# CITY OF ALBUQUERQUE

**Re: Storage Facility for Derron Havehor - 809 Locust St., SE**  
**Request for Certificate of Occupancy- Transportation Development**  
Architect's Stamp dated 3-10-16 (K15D096)  
Certification dated 11-30-16

RE: TRAFFIC CIRCULATION LAYOUT - STORAGE FACILITY FOR DERRON HAVENOR - 809 LOCUST ST. S.E., ALBUQUERQUE, NEW MEXICO - ARCHITECT'S STAMP DATED 3/10/2016 - PLAN DATED MARCH 2016 - **F15-D096**- ZA MAP F-15 - **FINAL SITE CERTIFICATION**

1 TRAFFIC CONTROL PLAN Scale: 1" = 10'-0"

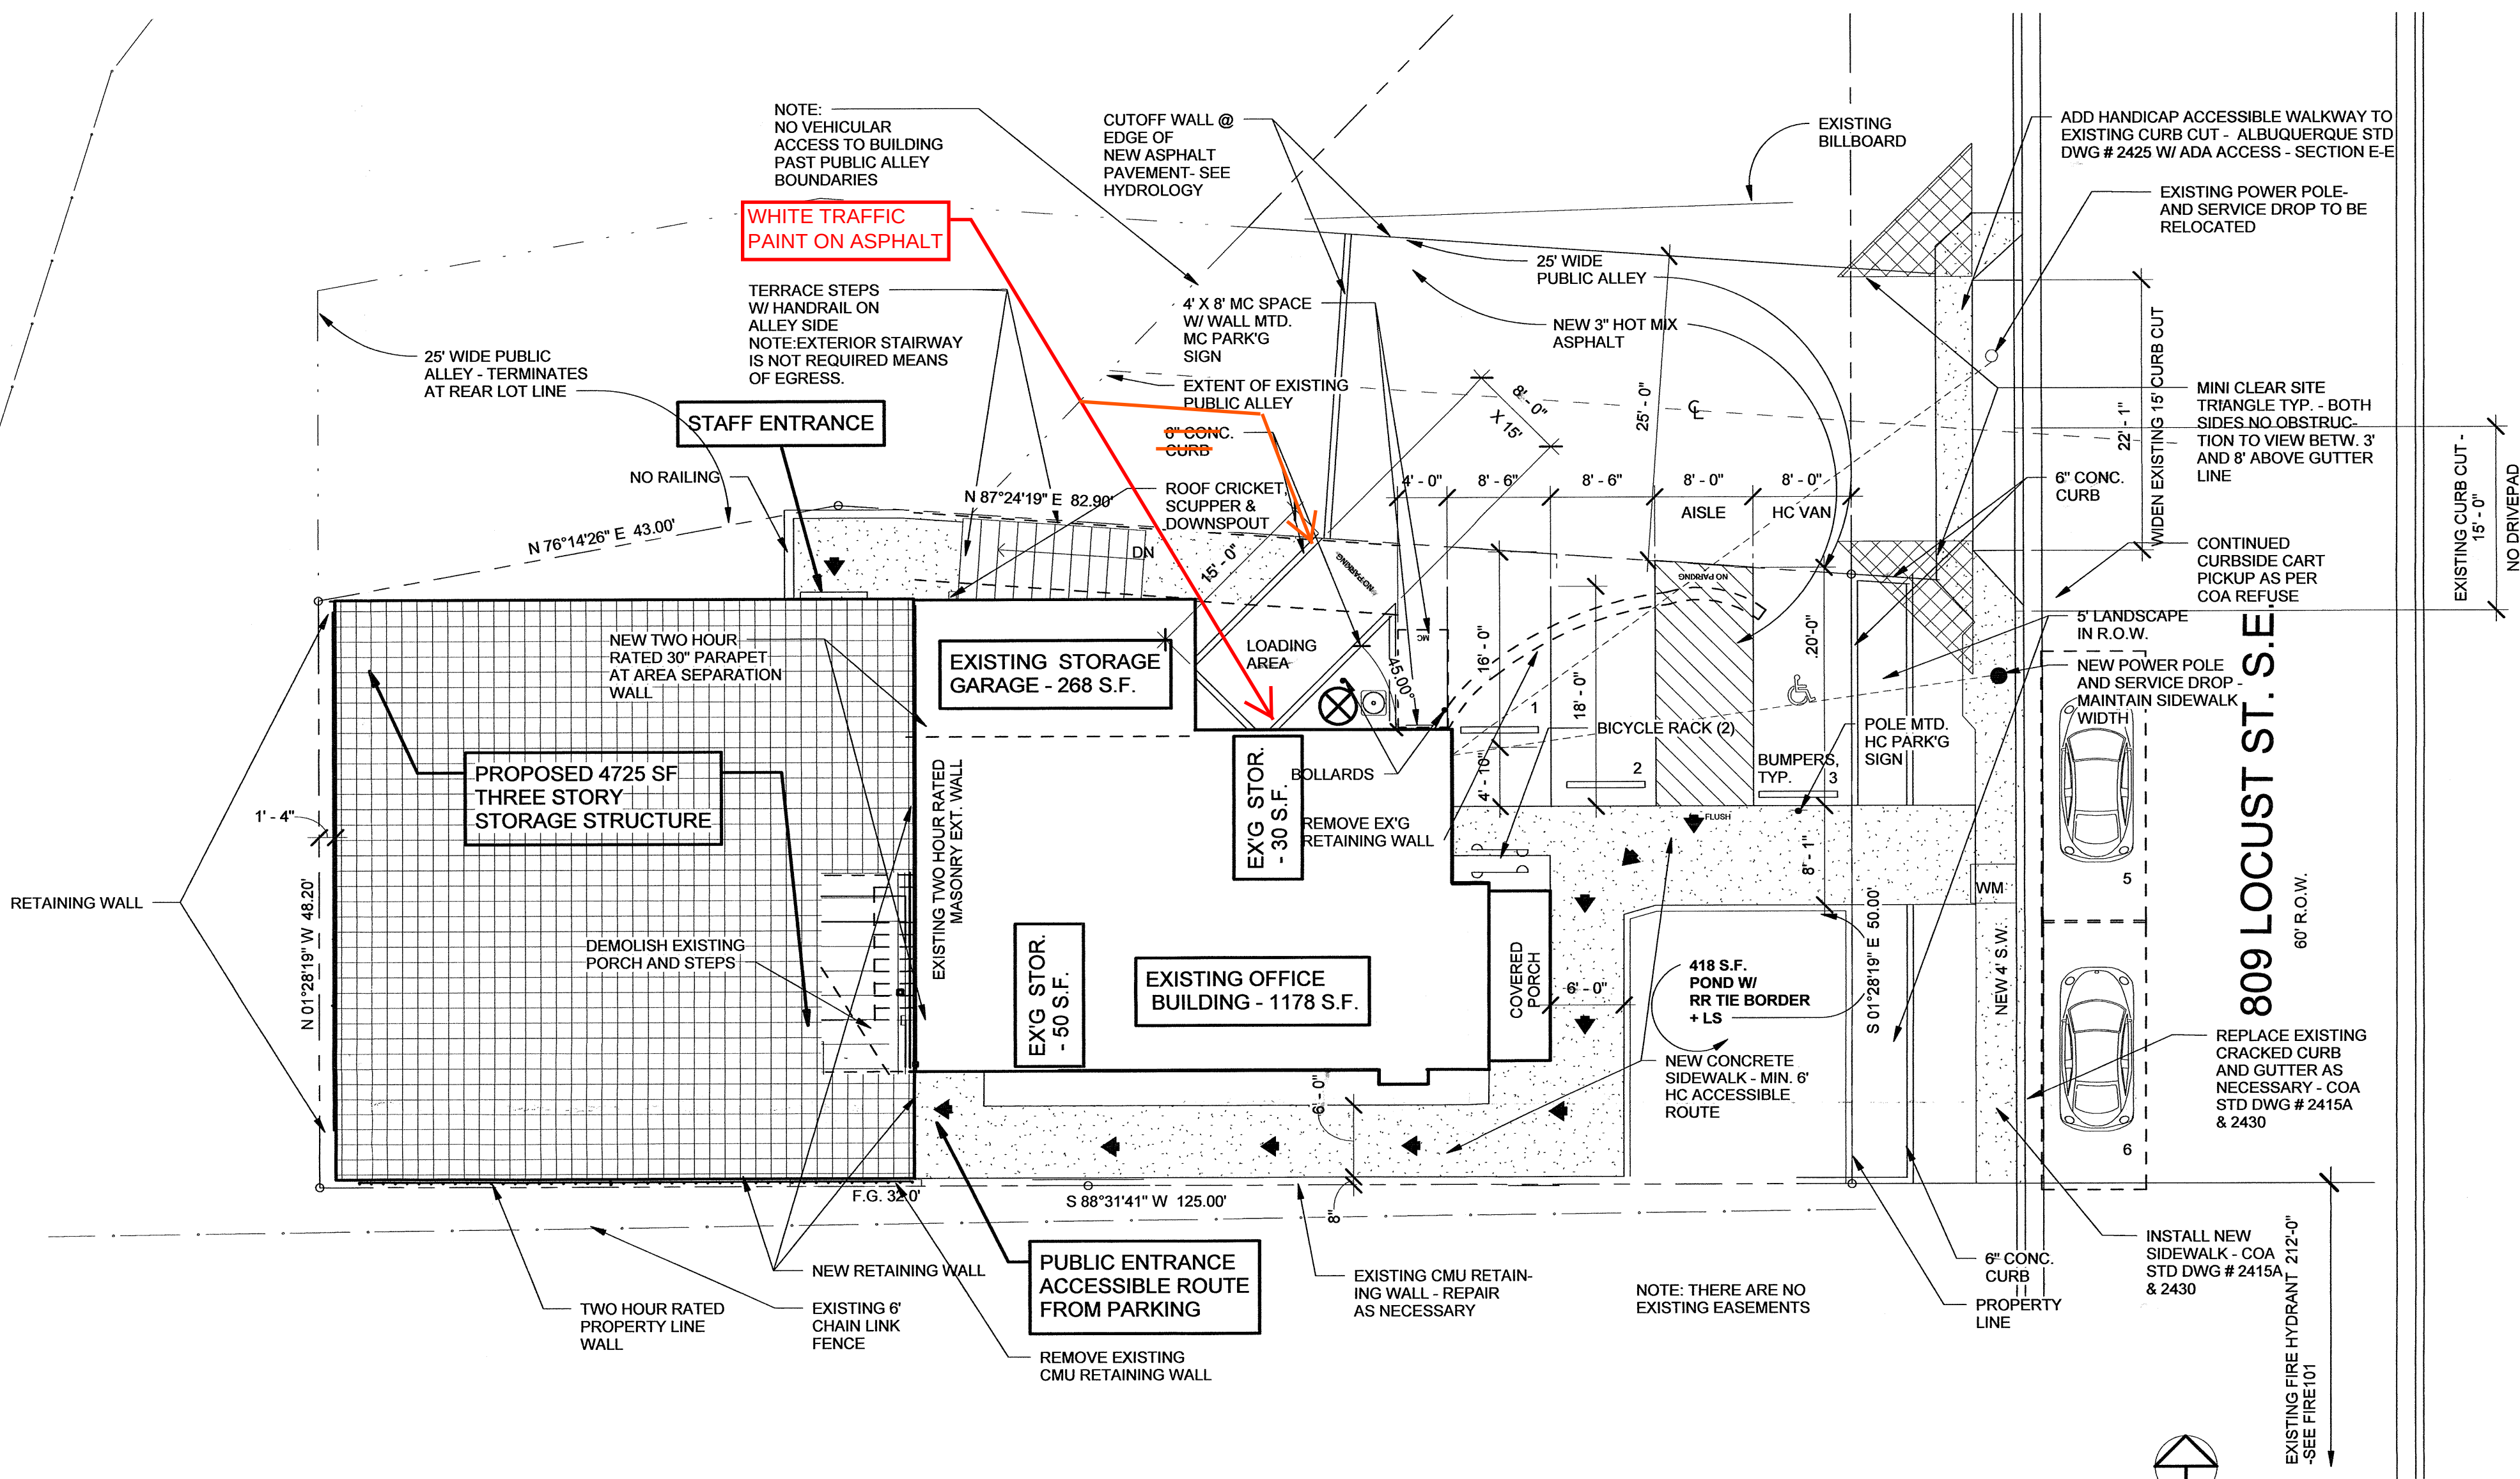
I FURTHER CERTIFY THAT I HAVE PERSONALLY VISITED THE PROJECT SITE ON NOVEMBER 30, 2016. THE ONLY MINOR CHANGE OBSERVED: THE CONCRETE CURB THAT DEFINED THE LOADING SPACE HAD BEEN DELETED. WHITE TRAFFIC PAINT ON ASPHALT NOW DEFINES THE LOADING SPACE.

Based upon the information provided in your submittal received 12-16-16, Transportation Development has no objection to the issuance of a Permanent Certificate of Occupancy. This letter serves as a "green tag" from Transportation Development for a Permanent Certificate of Occupancy to be issued by the Building and Safety Division.
